Queen of the Holy Rosary Catholic Church  
Diocese of Victoria  
Project #1024-0623

**ADDENDUM NUMBER ONE**

**July 24, 2025**

**M15**  
3/4" = 1'-0"

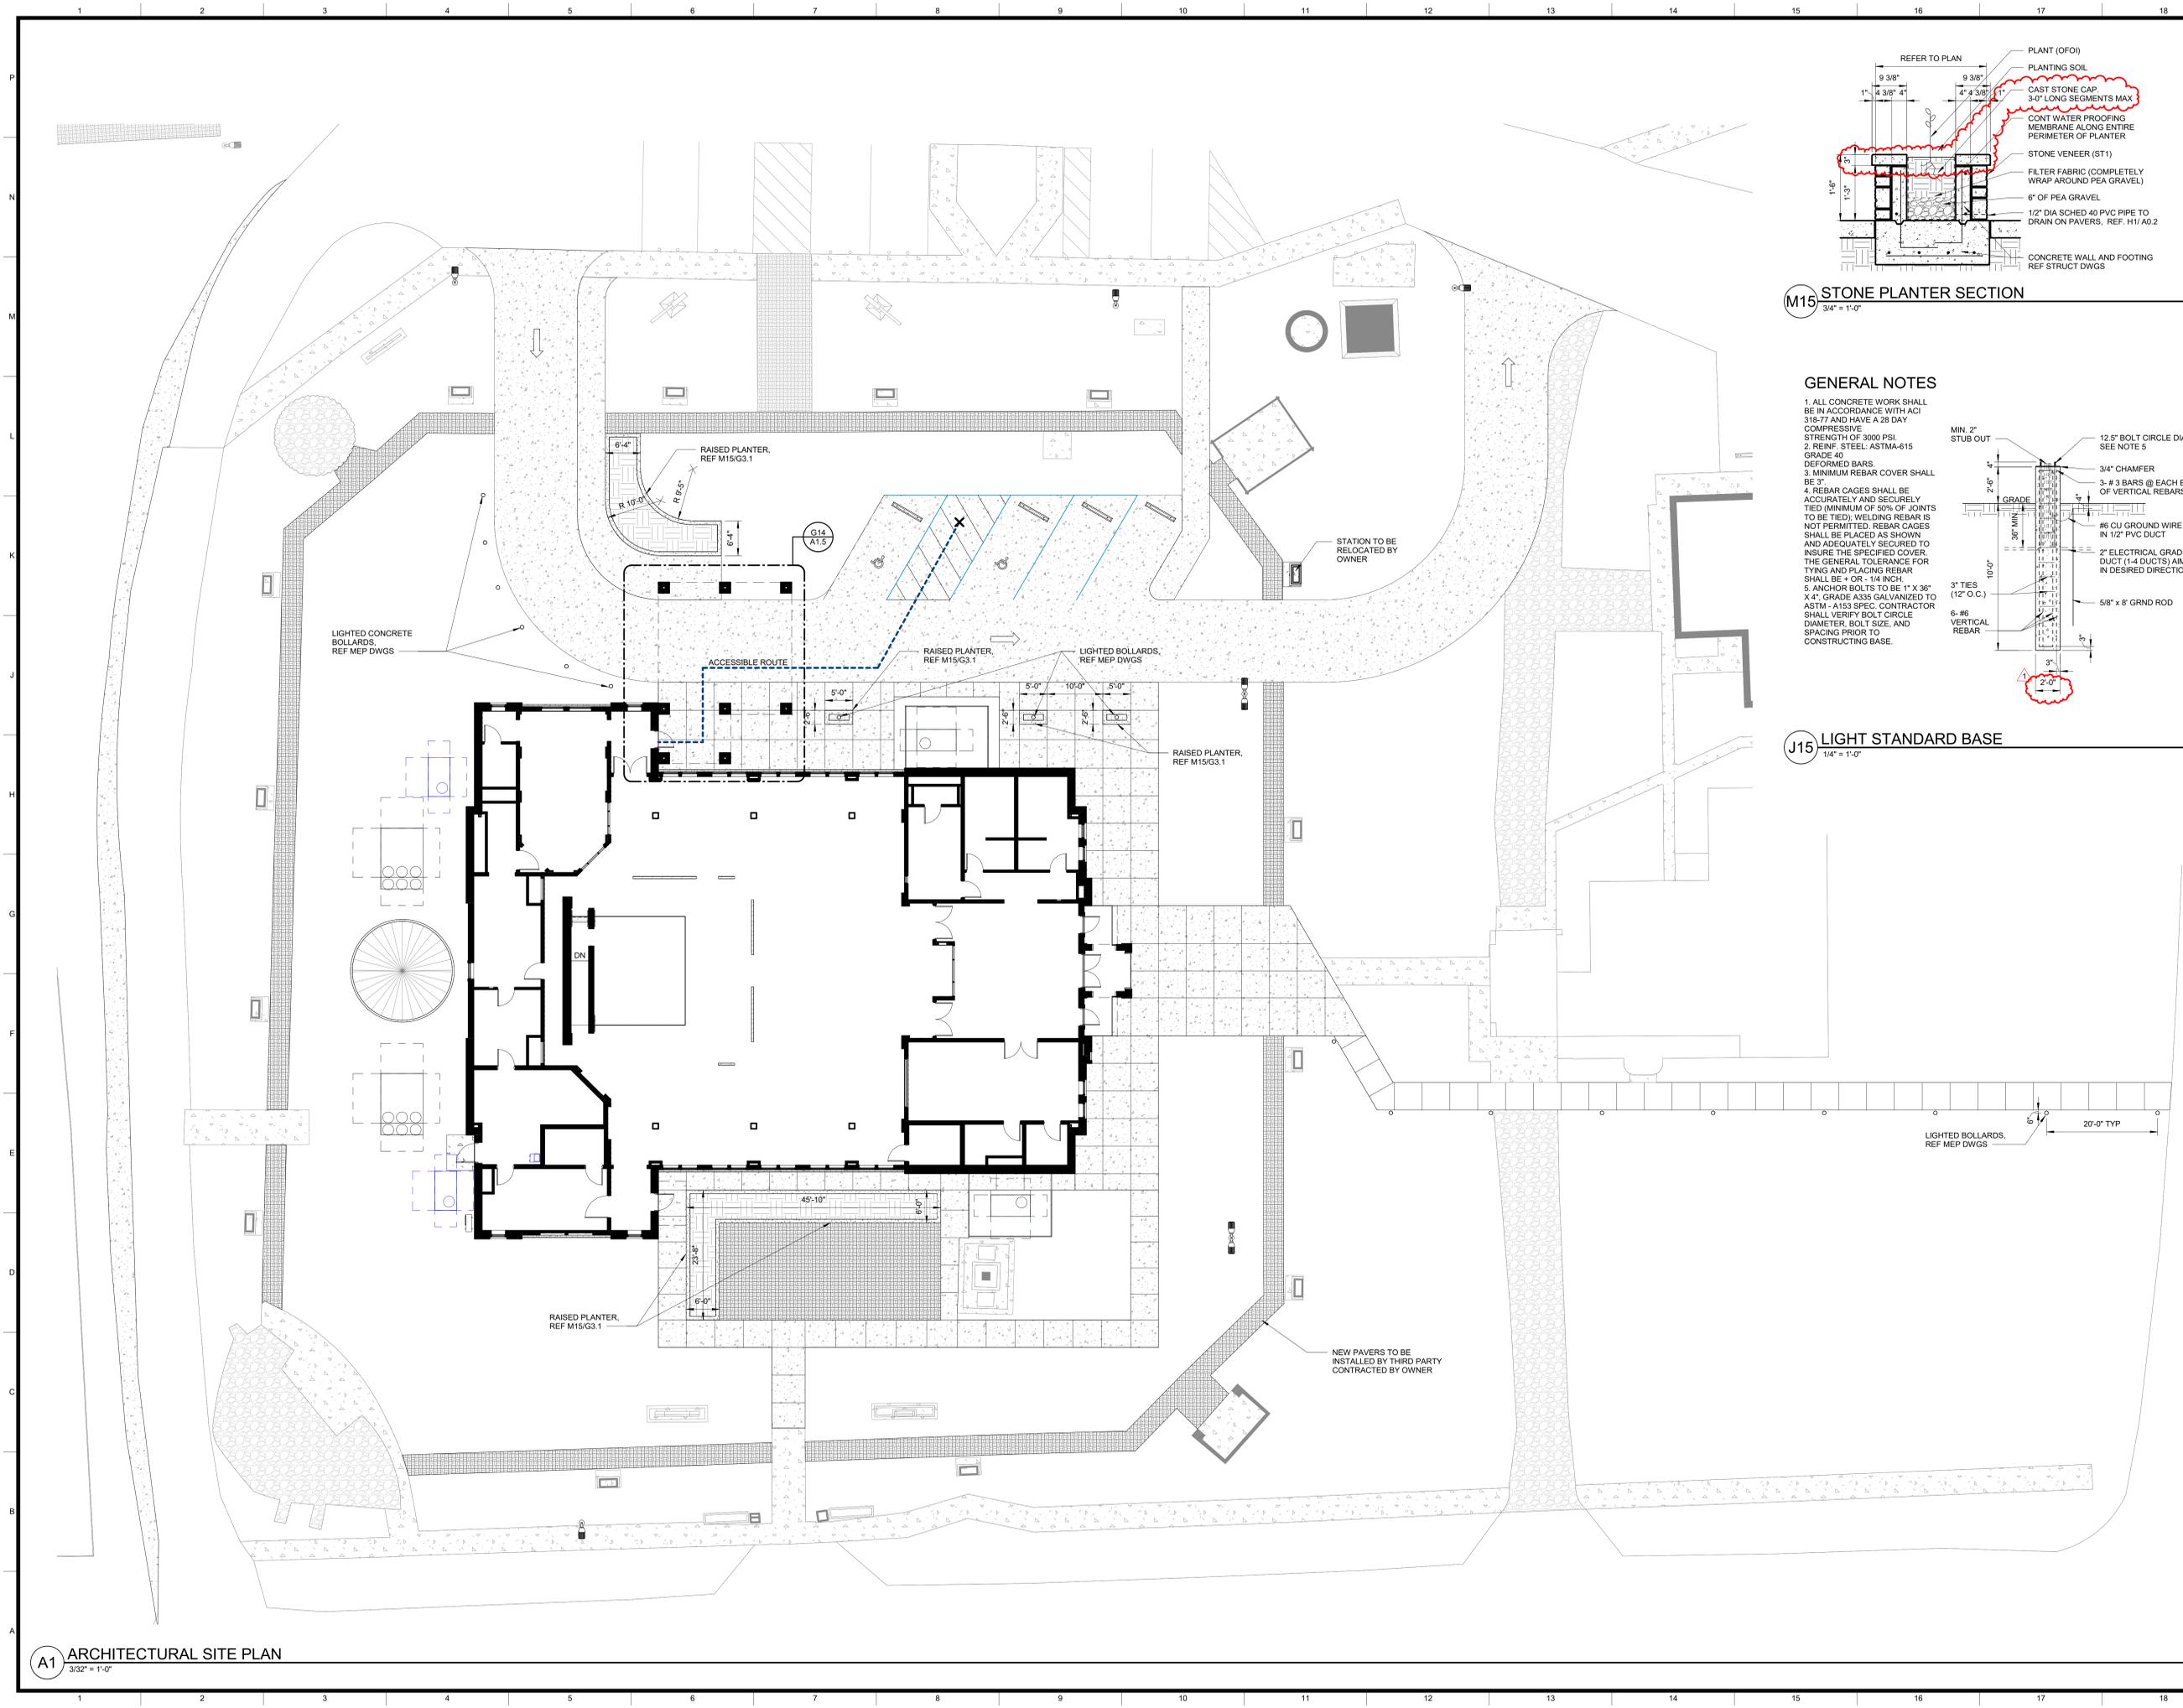
1. **Sheet G3.1 – ARCHITECTURAL SITE PLAN: M15 STONE PLANTER SECTION – Add** note and dimensions to cast stone cap per attached sheet G3.1R.
2. **Sheet G3.1 – ARCHITECTURAL SITE PLAN: J15 LIGHT STANDARD BASE – Add** dimension to concrete pier per attached sheet G3.1R.

**G3.2R**

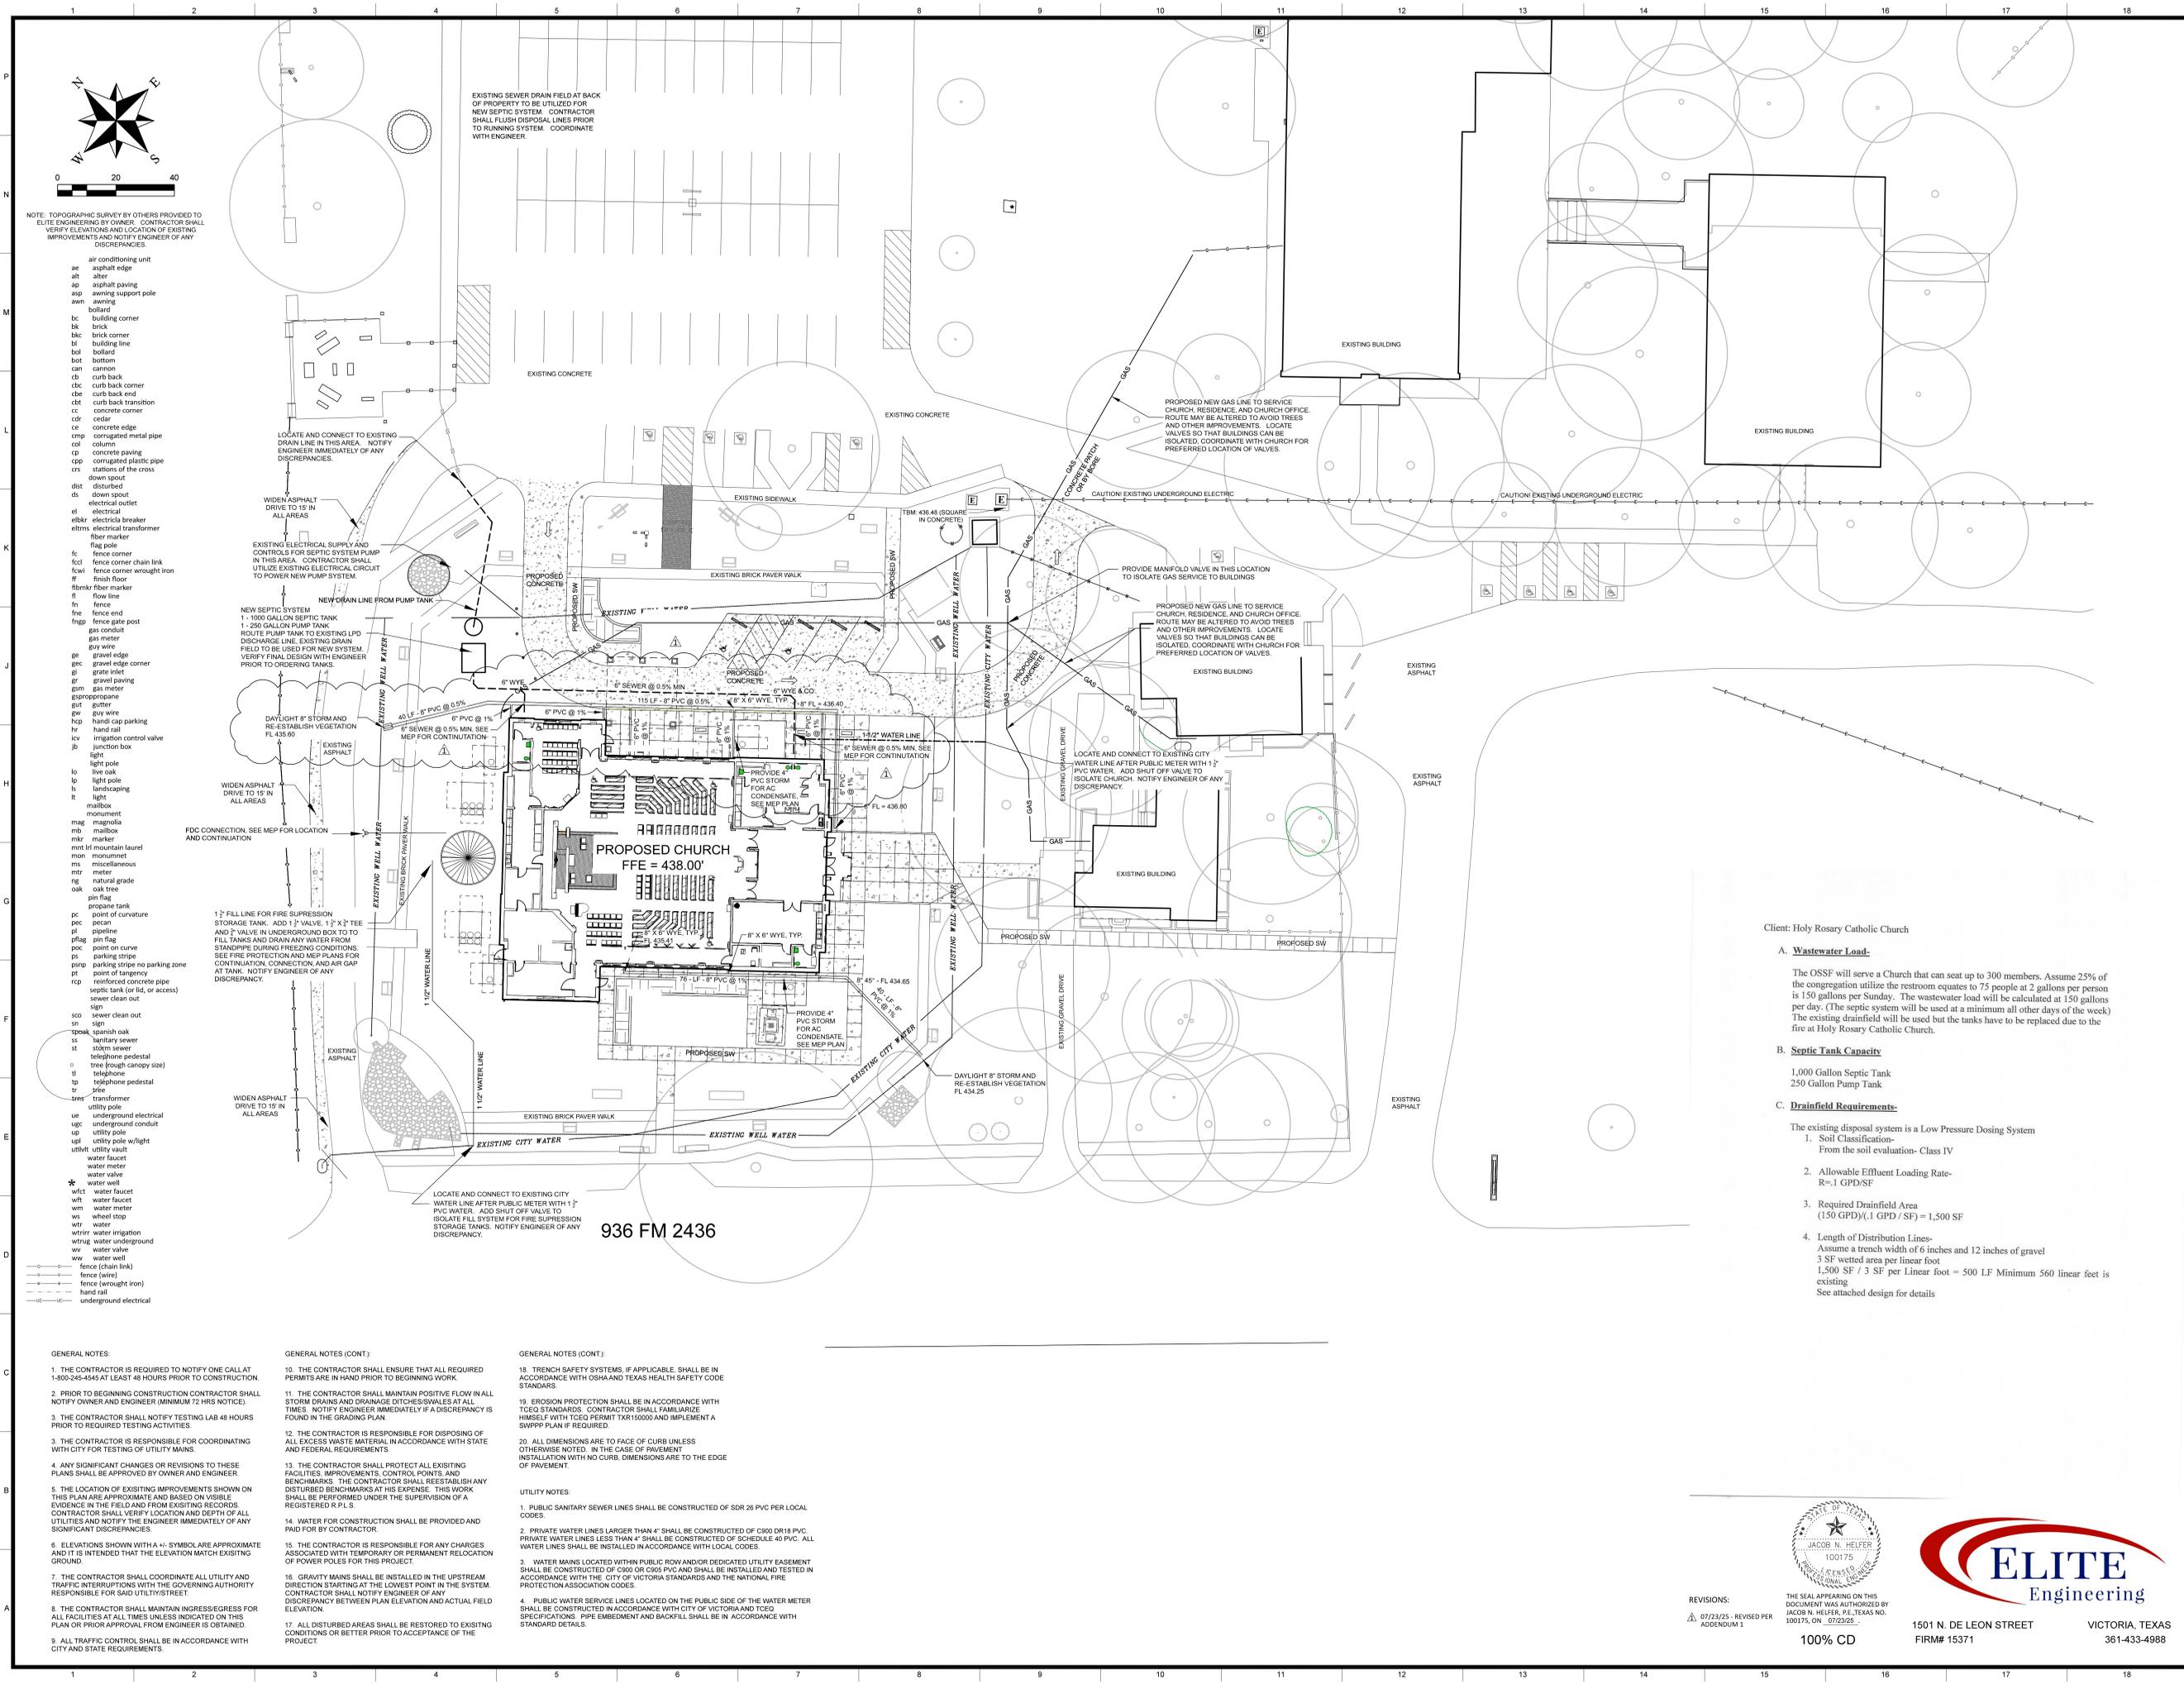
3. **Sheet G3.2 – ARCHITECTURAL DEMOLITION SITE PLAN: DEMOLITION KEYNOTES – Add** NOTE #13 per attached sheet G3.2R.
4. **Sheet C4.0 – UTILITY PLAN: Revise** sewer and storm lines per attached sheet C4.0.

12	REMOVE EXISTING CONCRETE CANOPY FOOTINGS.
13	REMOVE EXISTING LIGHT FIXTURE AND POLE. PREP FOOTING AS REQUIRED FOR INSTALLATION OF NEW POLE AND LIGHT FIXTURE. REFER TO MEP DRAWINGS FOR FIXTURE TYPE AND CONNECTIONS.

**ROOF DRAIN DAYLIGHT**

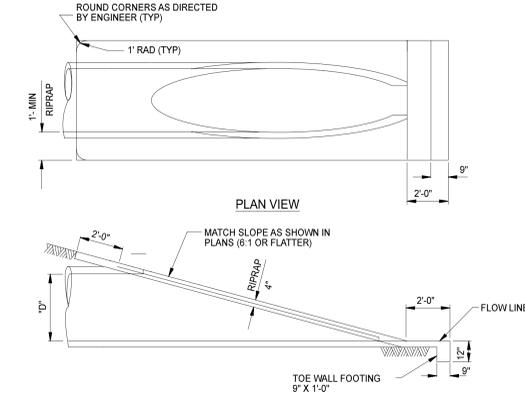
5. **Sheet C5.0 – GRADING PLAN: Revise** grades per attached sheet C5.0.
6. **Sheet C6.0 – DETAILS: Remove** monolithic curb detail and **add** roof drain daylight detail per attached sheet C6.0.
